Permit Application No.: 16-221

Applicant: **Metropolitan Council**

Project: **METRO Green Line LRT Extension (SWLRT)**

Figure 2: Construction Sheet Pile Cell

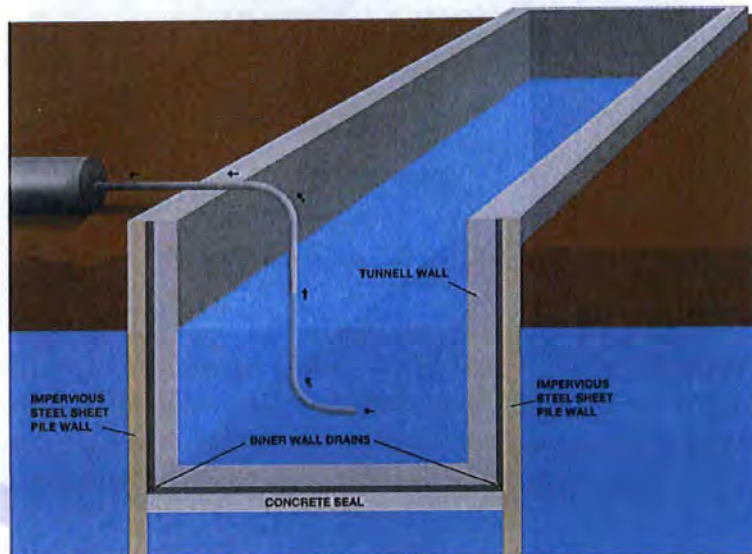
The tunnel construction method presented in the BODR is intended to eliminate the need for active dewatering by isolating the tunnels from groundwater. Beginning at each end of the north and south tunnels the construction will be segmented into roughly 150-foot long by 37-foot wide cells.

Prior to any excavation, each section will be isolated from any adjacent groundwater by driving sheet piling around its perimeter. Next, the soil within each section will be excavated to the proposed depth. In areas where the proposed depth is below the water table, a clam shell bucket will be used to wet-excavate the soils without any pumping of groundwater. After, the soil is excavated to the proposed depth; a concrete slab will be poured to seal the base of the tunnel from the underlying groundwater. In areas where the base of the excavation is below the water table, the concrete will be tremmed into place below the water level to create a seal. After the concrete has cured and the seal has been established, any water remaining in the now-sealed excavation will be pumped out (Figure 2). For the segments beneath the water table, there will likely be some leakage through the sheet piling and concrete slab as stated in the BODR and discussed in Section 2.4.

Figure 3: Portal Water Control System

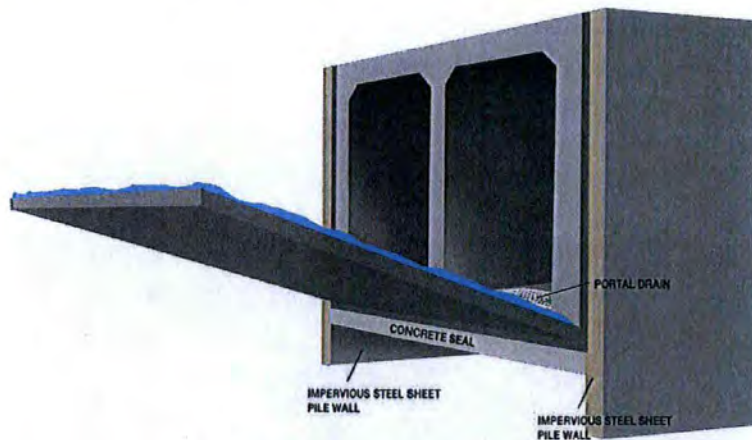
When the tunnel system is operating, water would be collected and managed from three different areas: the portals, inner walls and the tunnel. The portals, or entrances/exits of the tunnel, are uncovered and open to rain and snow. Stormwater and snowmelt from the portals would be collected in drains at the base of the portals that are designed to capture a 100-year design storm event. Water captured would be pumped into chambers and infiltrated to groundwater (Figure 3:

Portal Water Control System). Runoff volumes in excess of the chambers' 50-year design storm event volume will overflow from the chambers and discharge into the storm sewer system before the chain of lakes. All design storm events are based on National Oceanic and Atmospheric Administration (NOAA) Atlas 14 rainfalls (Metropolitan Council, 2013).

Figure 4: Inner Wall Water Control System

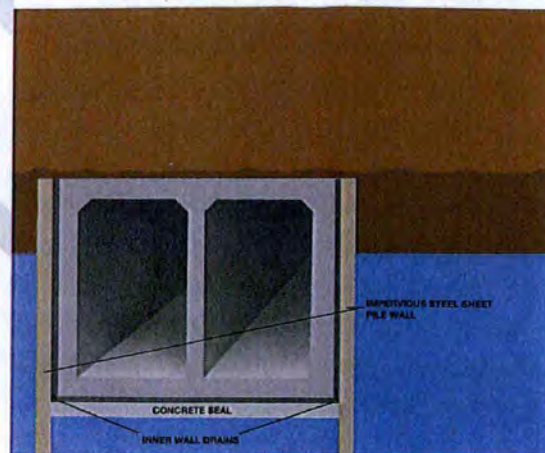
The inner wall (external shallow LRT Tunnel Water Control System) drainage collection area is located between the outside of the tunnel walls and floor of the tunnel and the initial sheet piling and concrete seal (Figure 4). This area would collect any groundwater that seeps through the sheet piling and concrete seal. That water would be routed to a chamber and returned to the groundwater system.

Figure 5: Tunnel Water Control System

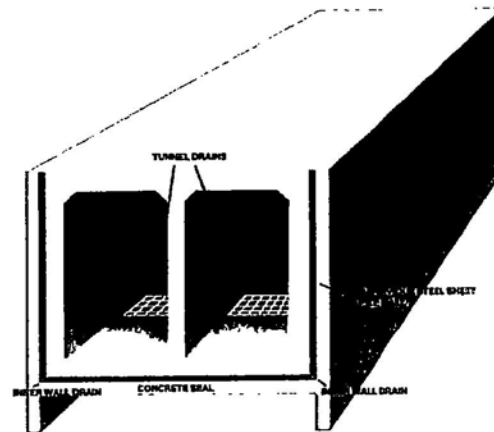
And finally, any water collected inside the tunnel from stormwater, snowmelt and groundwater seepage would be collected in storm drains. That water, which may come in contact with potential

contaminants, would be pumped to the City of Minneapolis or Metropolitan Council Environmental Service (MCES) sanitary sewer system (Figure 5).

Figure 6: Groundwater Piezometer Data (Vayen, 2013)

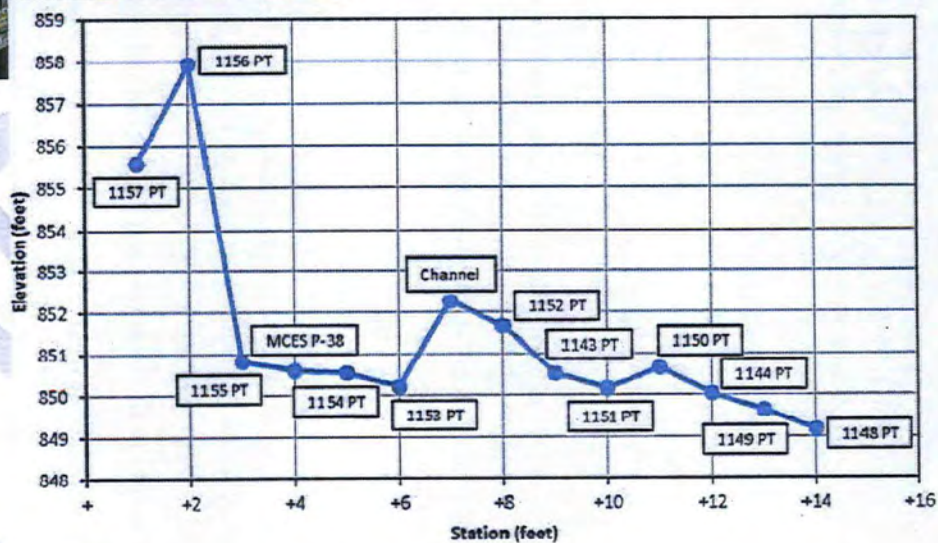
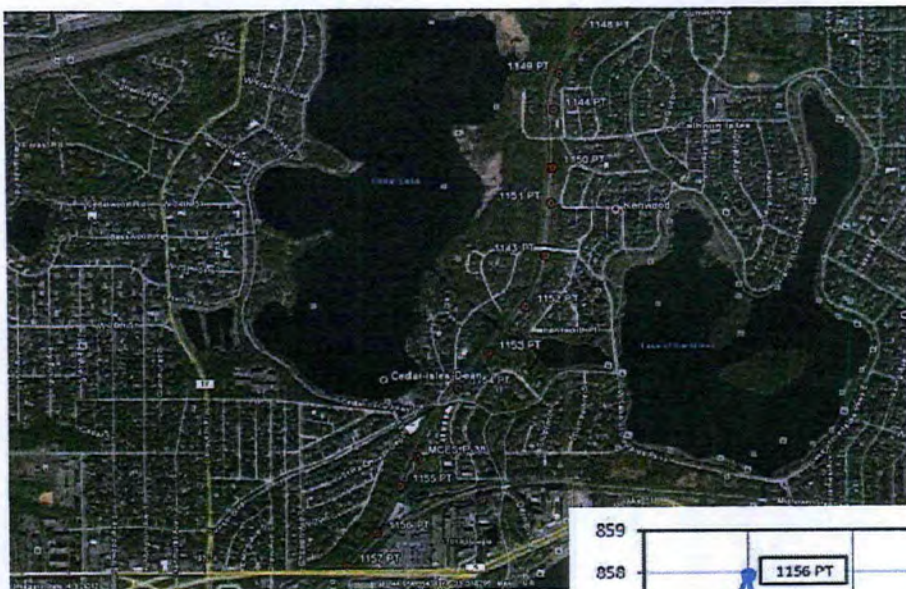
of the Isles indicate a downward gradient, so that the primary flow direction may be downward to a more transmissive aquifer at depth

Since the AFT piezometers are installed only along the proposed route in the Kenilworth Corridor, they only provide a one dimensional view of the groundwater elevations and it is difficult to conclusively determine the groundwater flow pattern. Additional piezometers lateral to the proposed route are needed to better characterize the groundwater flow system in two dimensions, and a few nested piezometers completed at a greater depth would help to evaluate potential downward flow. Also, the water levels presented are only from October and November 2014. Seasonal water level data are needed to better understand ground water elevations during wet periods and in response to rain events.
